August 10, 1990
PY-CEI/NRR-1208 L

Perry Nuclear Power Plant
Docket No. 50-440
CEI Response to NRC Request for
Additional Information re
Inservice Inspection Relief Requests

By letter dated June 13, 1990, the NRC staff requested additional information regarding Perry Nuclear Power Plant (PNPP) Inservice Inspection Relief Requests PT-001, PT-002, PT-003 and IR-017 in order to complete a review of eleven relief requests submitted by the Cleveland Electric Illuminating Company (CEI) via letter PY-CEI/NRR-1078L dated November 17, 1989.

Relief Request IR-016

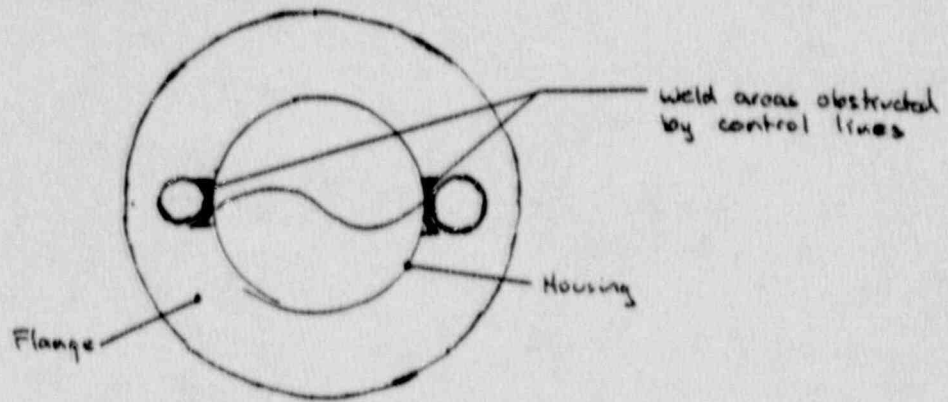
Inservice Relief Request IR-016 was submitted to request relief from 100% volumetric examination of the reactor head spray nozzle to vessel weld (1B13-N8-KA) and nozzle inner radius (1-B13-N8-IR). The volumetric examinations are required by ASME XI, Examination Category B-D, Items No.'s B3.90 and B3.100 respectively. As reported in Preservice Relief Request #1, the exams are limited by the close proximity of the adjacent N-7 nozzle. Prior to Perry's first refuel, the NRC requested that Inservice Relief Requests, for known limitations, be submitted for the first interval. Inservice Relief Request IR-001, submitted to the NRC by letter PY-CEI/NRR-0919L, listed the head spray nozzle exams on page 8 of 9 of the relief request. The head spray nozzle exams were scheduled for, and performed, during Perry's first refueling outage. Following the outage, not realizing that relief had already been requested, Relief Request IR-016 was prepared in error. It should also be noted that the completion percentage reported for the inner radius exam in IR-016 (83%) was calculated in error and the completion percentage reported in IR-001 (94%) is correct.

OVERHEAD VIEW

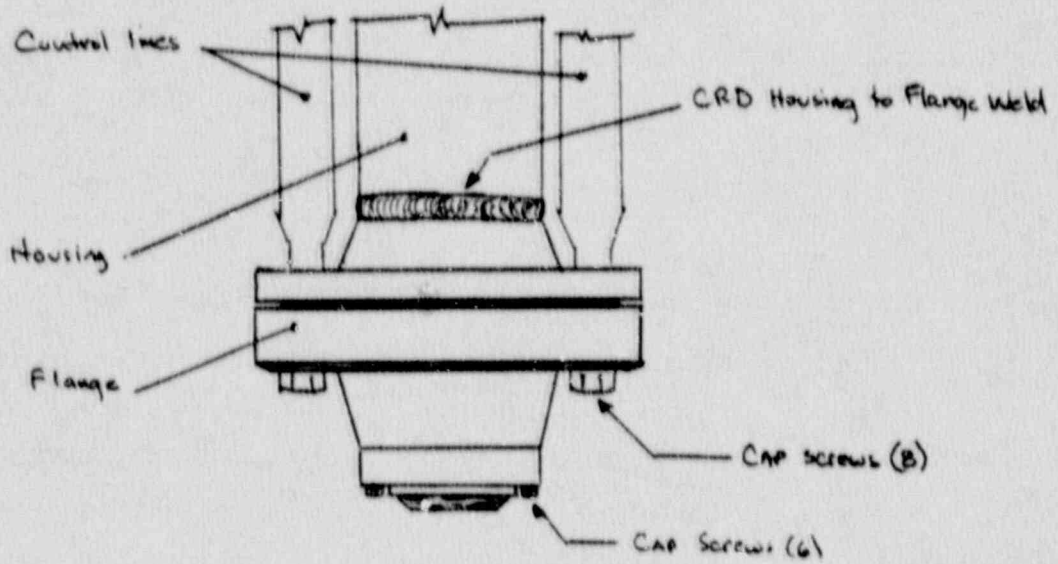
CEI has also determined the need to clarify the relief requested in Preservice Relief Request #11 (and subsequently resubmitted as Inservice Relief Request #IR-009) with regard to the staff's (NRC) evaluation in Appendix Q of the Perry SSER No. 7. Relief from 100% surface examination of the Code required examination area was requested for the CRD housing flange welds. The surface examinations are required by ASME XI, Examination Category B-0, Item No. B14.10. The relief is necessary as 15% of the surface examination area of each housing to flange weld is inaccessible due to obstruction by the control (inlet and withdraw) lines (see Attachment 3, page 2 of 2). The control lines closely parallel the CRD housing and are welded into the CRD flanges. The staff concluded that "removal of the installed CRD support structure" solely for the purpose of performing the required surface examination was not necessary, but should the CRDH's be "disassembled" for inservice repair or maintenance, such that the subject welds are accessible, the surface examinations would be required to be performed at that time. The CRD mechanisms are routinely disassembled for in-service repair or maintenance, but the disassembly does not provide access to the portions of the CRD housing to flange weld obstructed by the control lines. The Staff approval of the Inservice Relief Request #IR-009 transmitted by letter dated April 25, 1990 did not specifically repeat this requirement. However, we commit that in the event the control lines would be removed for repair or maintenance, the required examination will be performed.
